### SUBDIVISION REVIEW SHEET

<u>CASE NO</u>.: C8-2022-0112 <u>COMMISSION DATE</u>: September 6, 2022

**SUBDIVISION NAME:** Velocity Preliminary Plan

CITY OF AUSTIN -DEVELOPMENT SERVICES DEPARTMENT SUBDIVISION APPLICATION - MASTER COMMENT REPORT

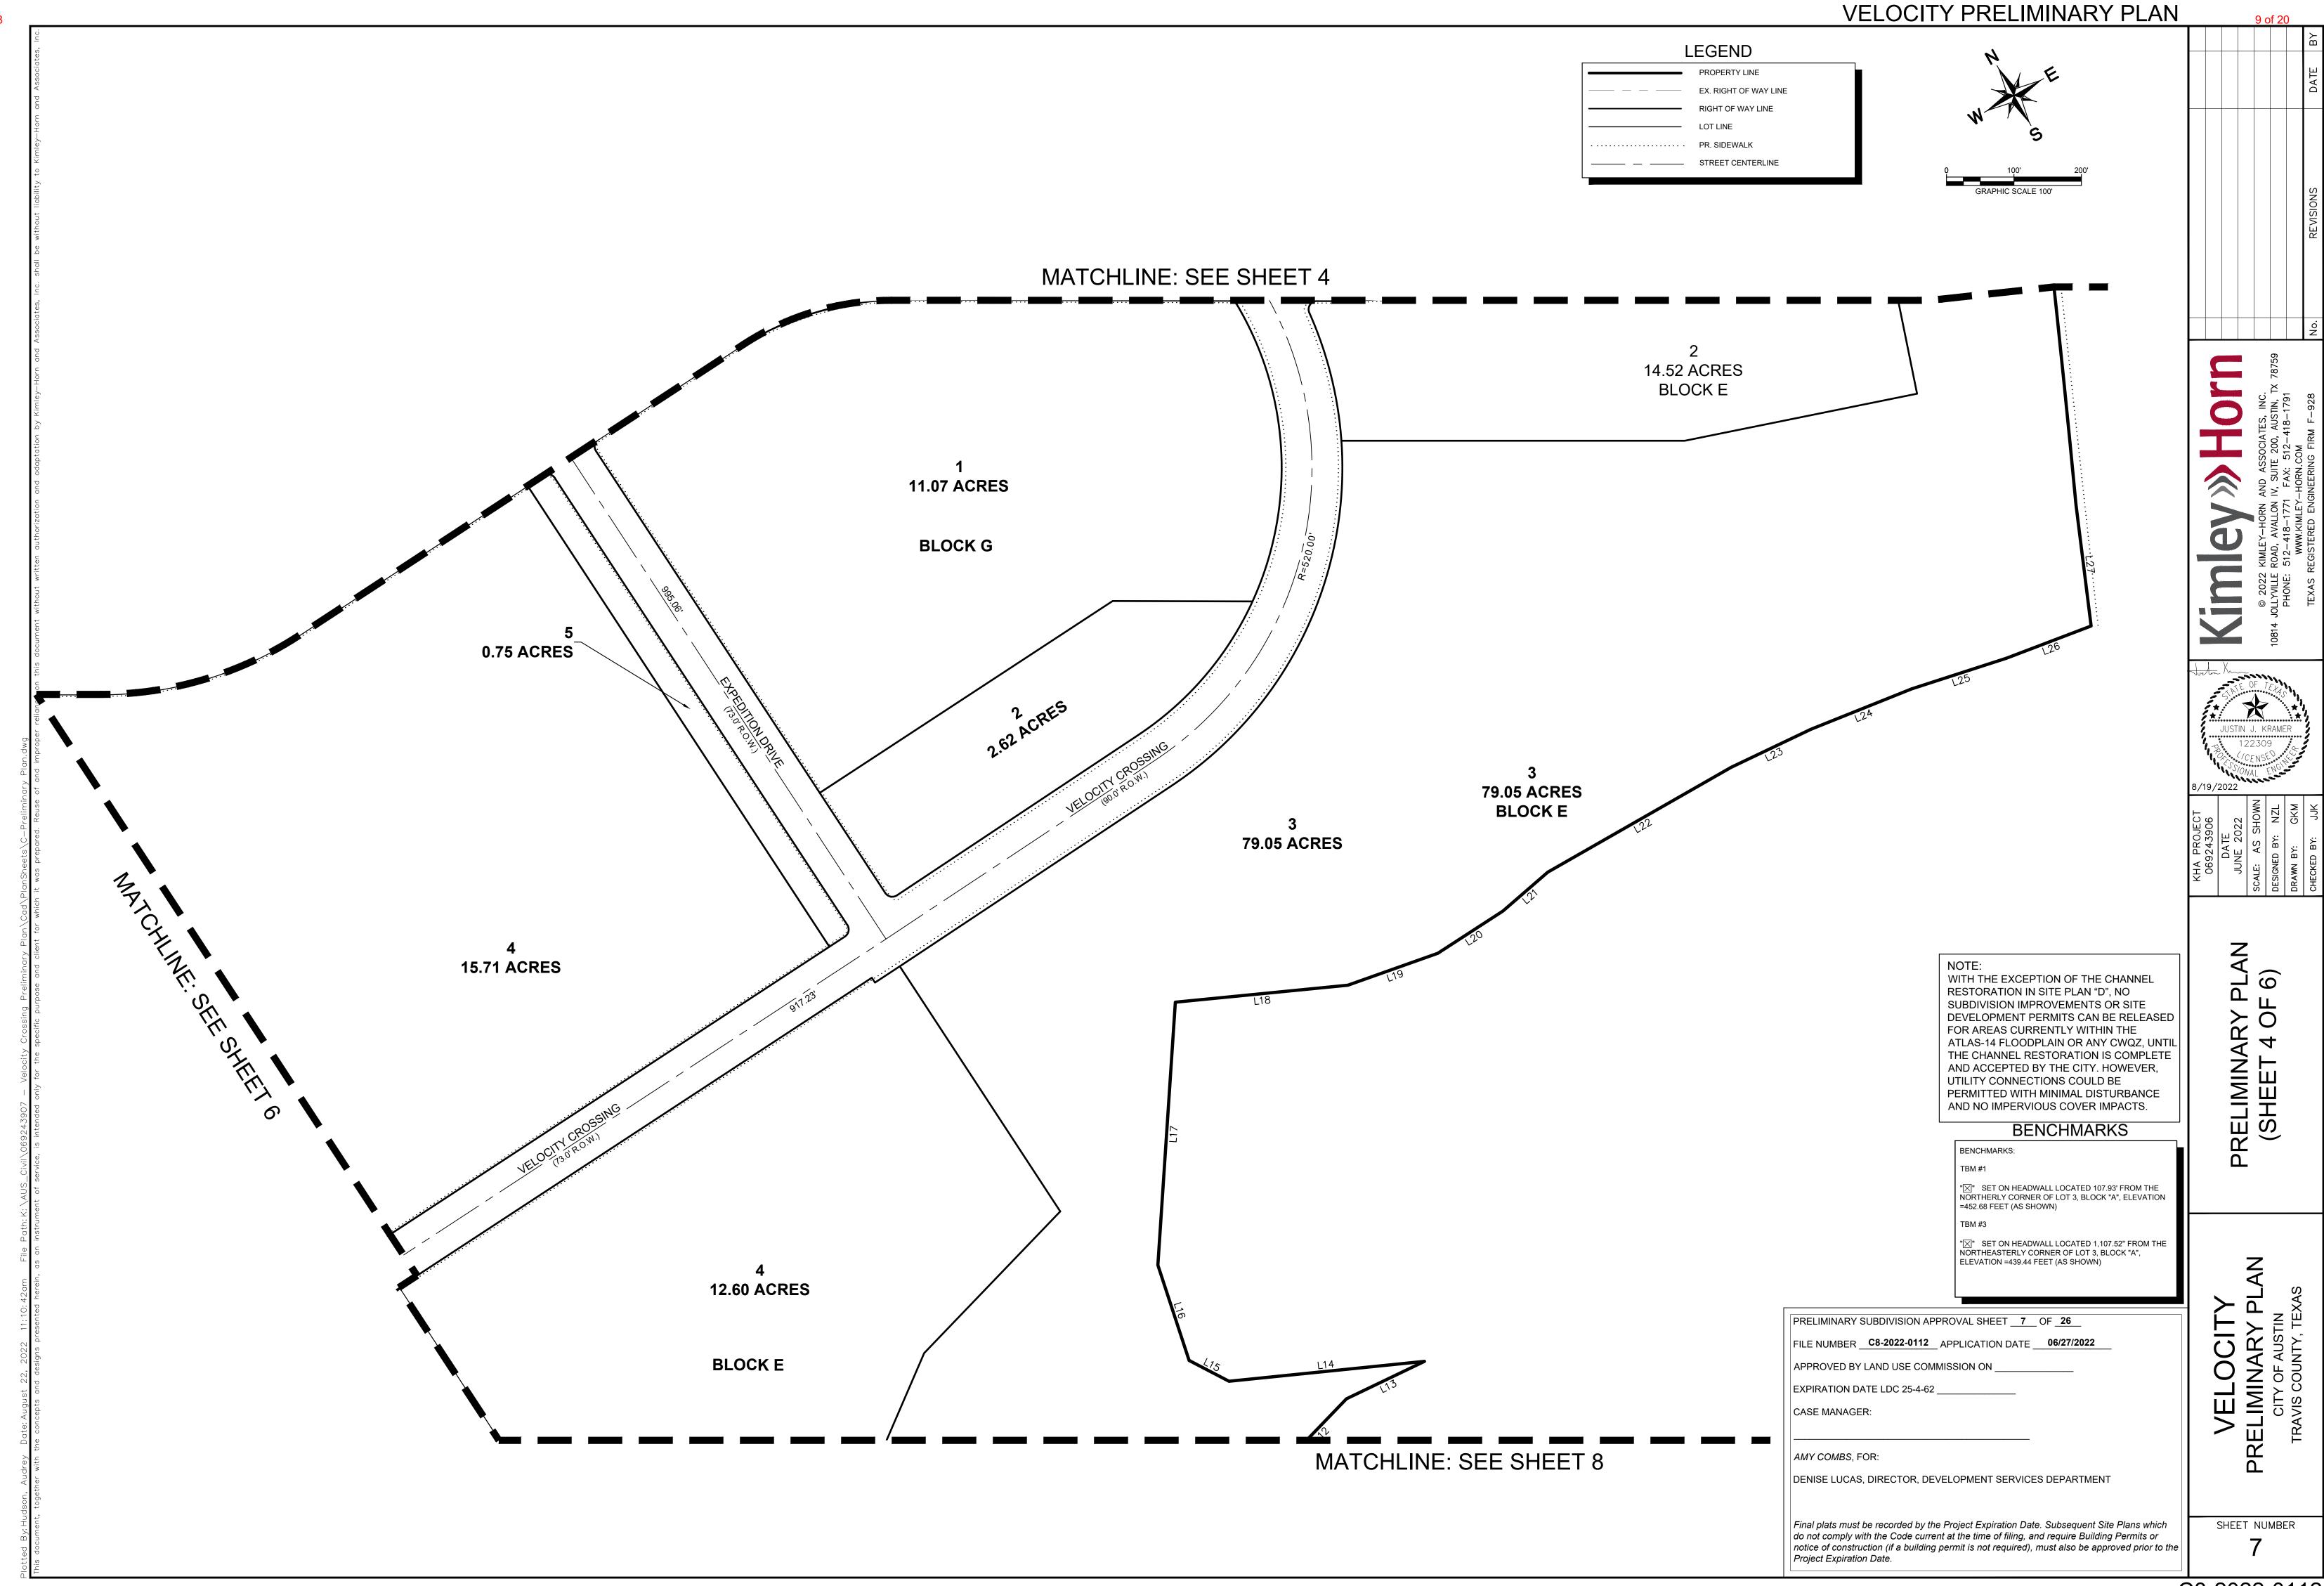
- **U1. Comment Cleared**, because the prior project assessment has expired, the recommendations from the project assessment do not apply
- **SR9.** Please remove all of the building footprints from the surrounding property- for instance on sheet 3 and sheet 5 there appears to be contours or building footprints for the surrounding property (25-1-83)
  - **U1. Comment Not Cleared.** On sheet 5 there still appears to be an outline?

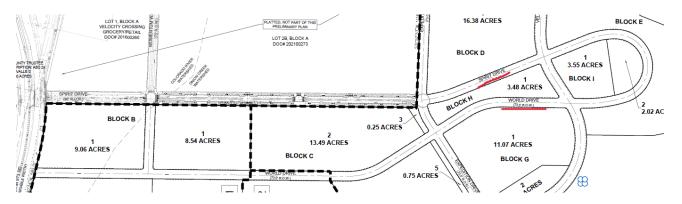
**AD1:** The segment labeled as SPIRIT DR and WORLD DR is actually one continuous street. You can do one of three things:

- 1. Name entire street Spirit Cir
- 2. Name entire street World Cir
- 3. Starting at Block 1, introduce a break so there is a corner that demarks the two streets.
